# Conceptual Review Agenda

Schedule for 10/17/16 to 10/17/16

# East Ridge Residential

# 3001 Elizabeth St. Triplex

NEW FLOOR PLAN 1/4"=1'-0"

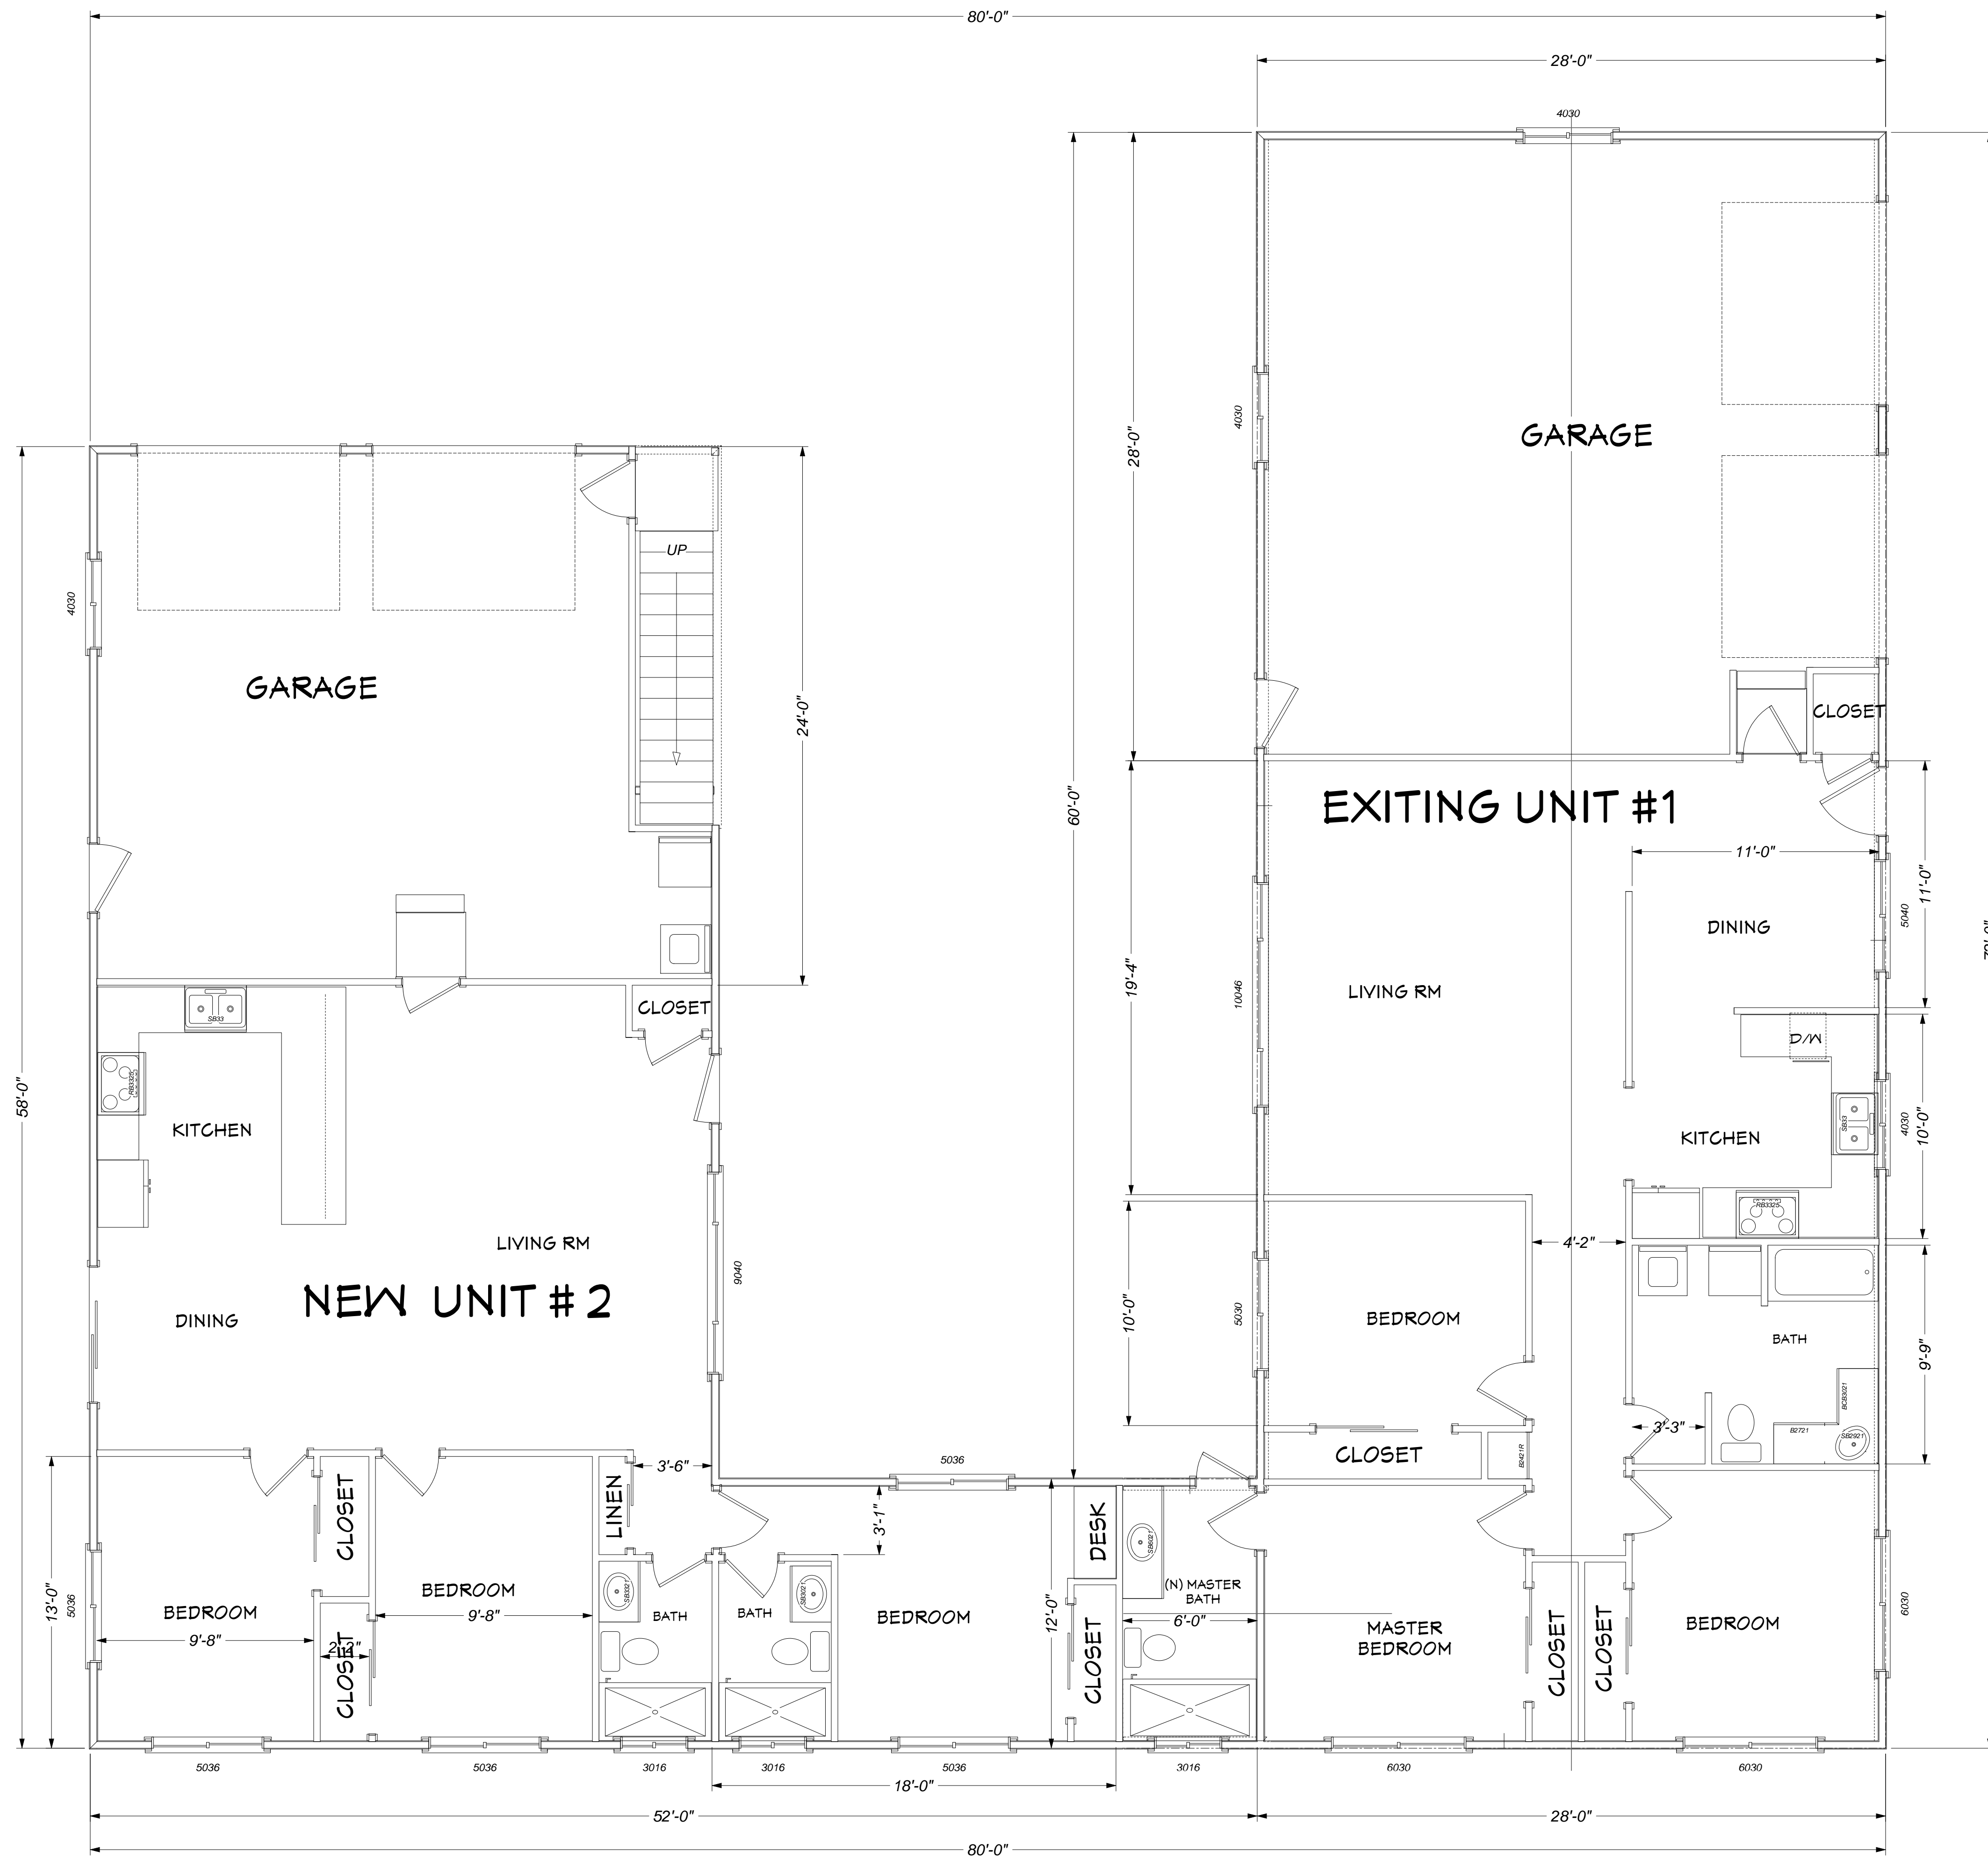
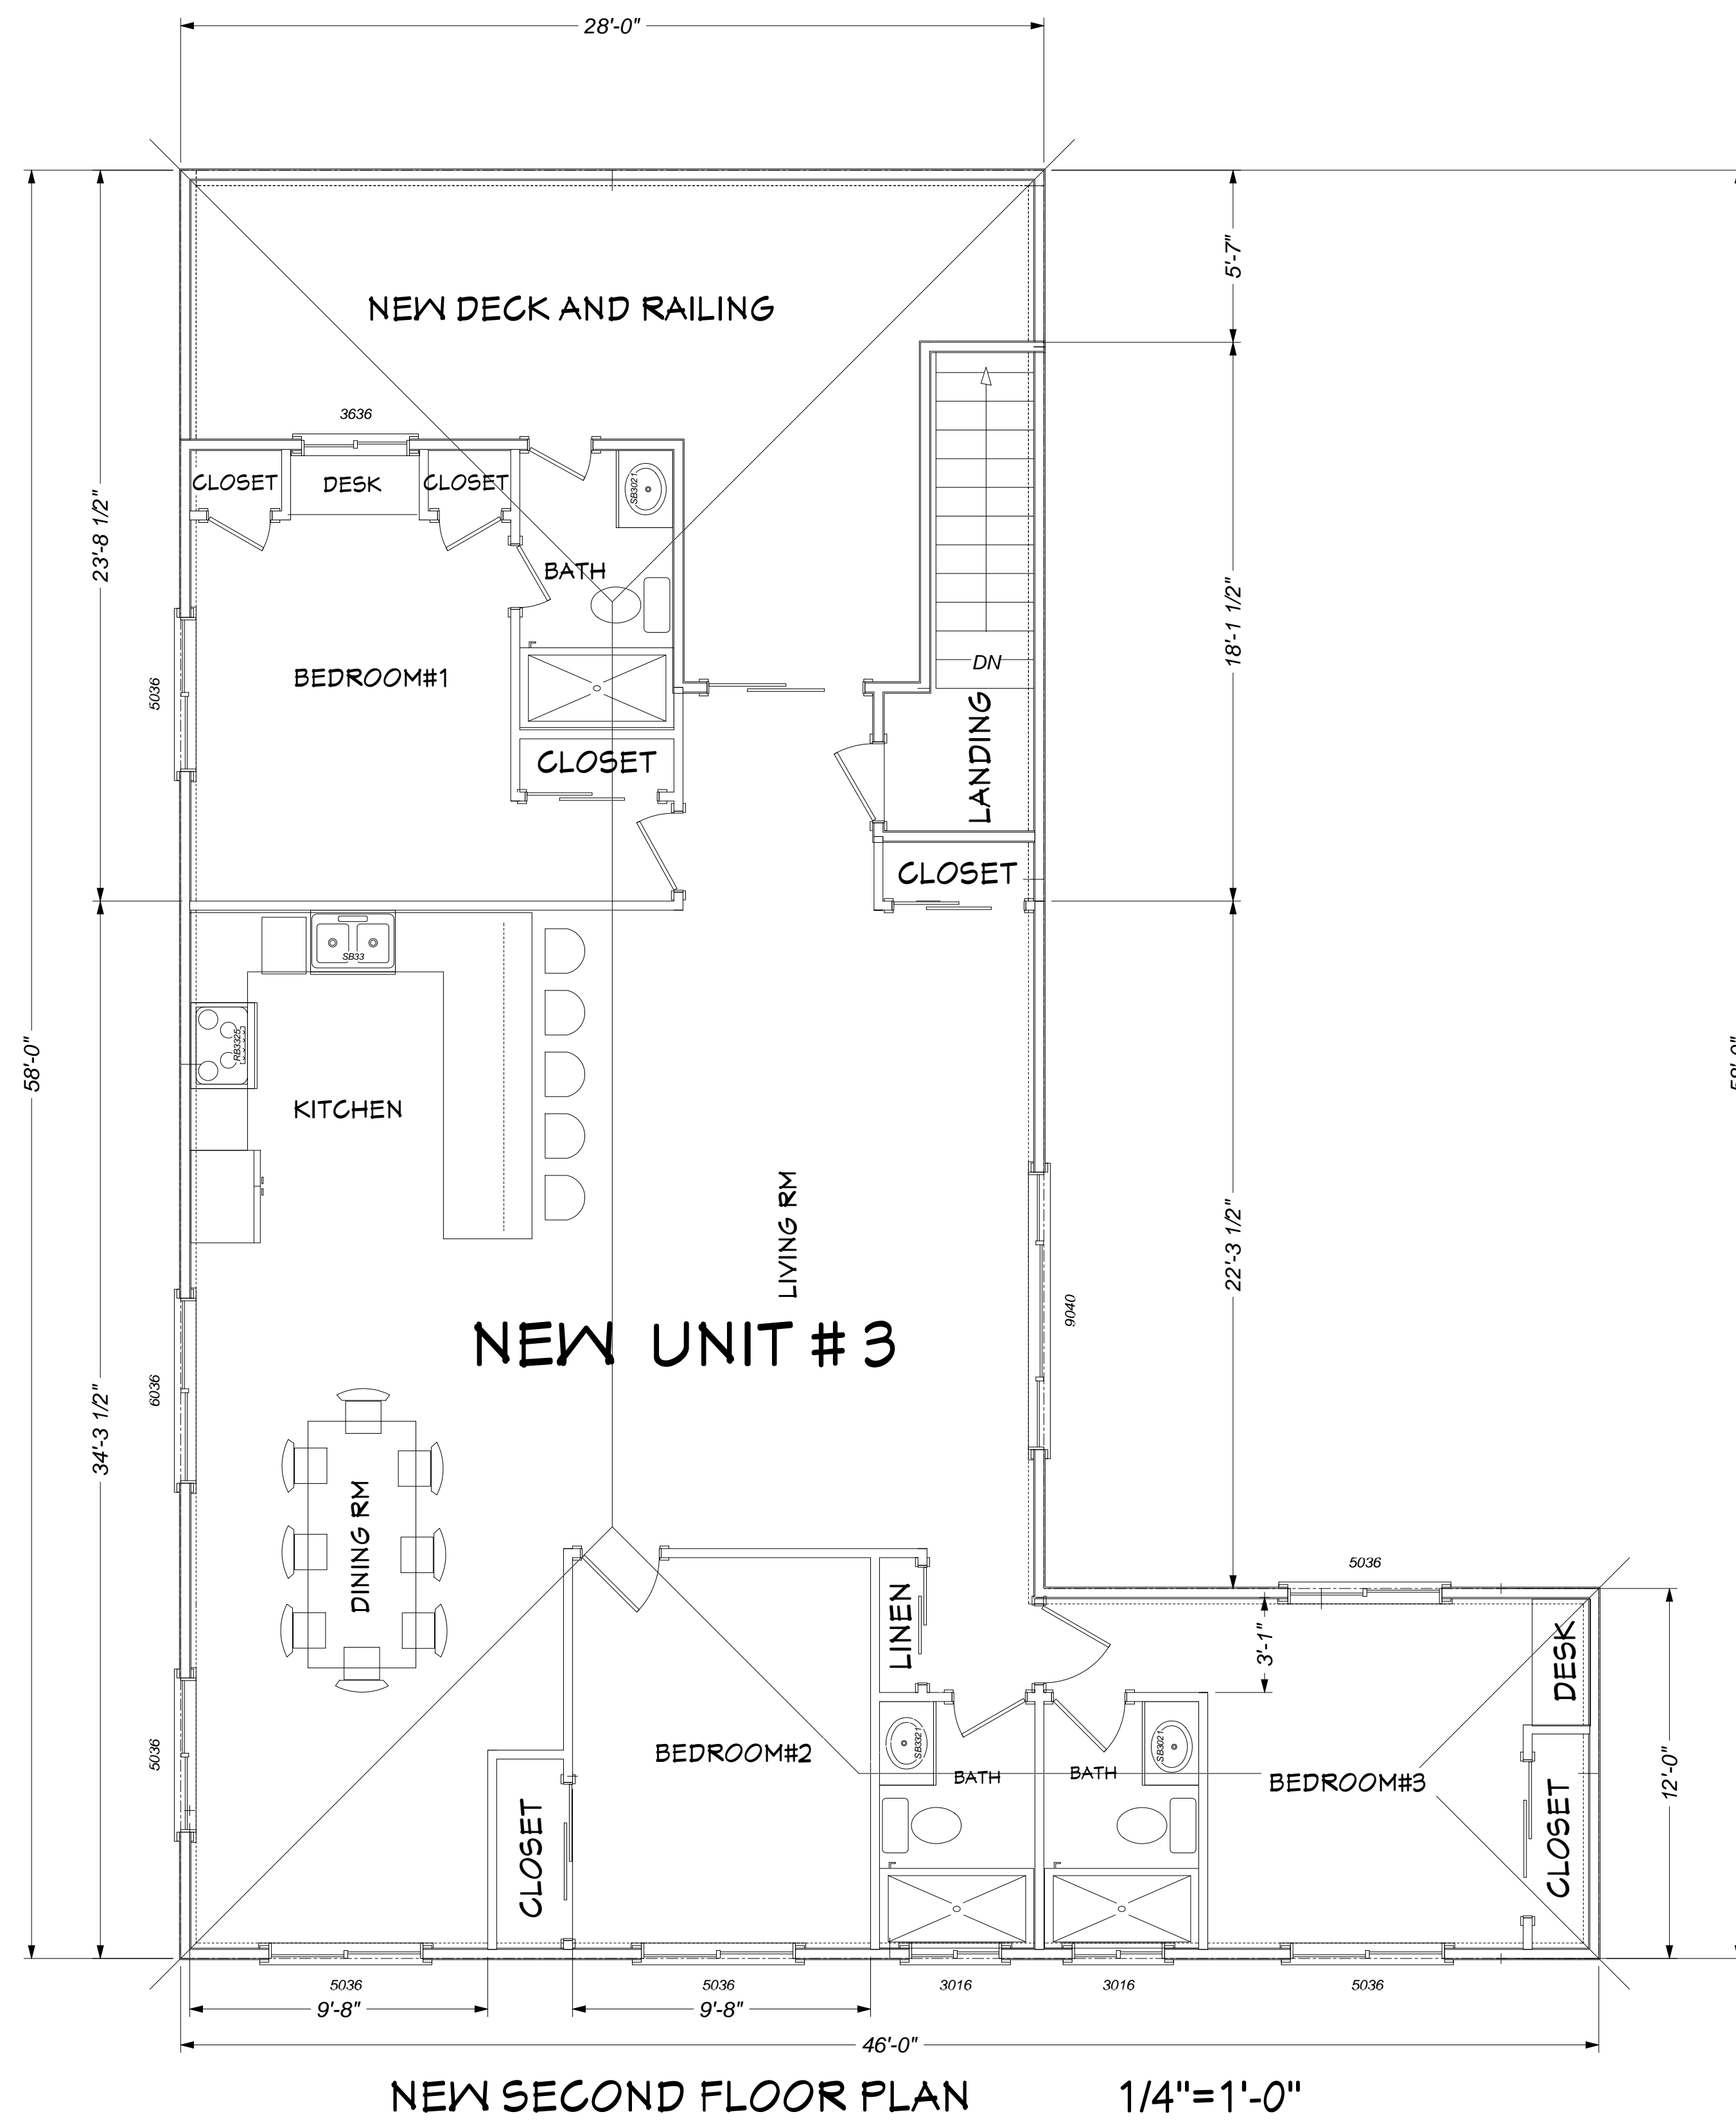
7. Where is the building entrance to the second and third units? Building entrances are supposed to be clear from public streets and other public areas through prominent architectural features. As shown, this plan does not meet this code requirement. You will either need to add more prominent entries or seek a modification to this code requirement as well.
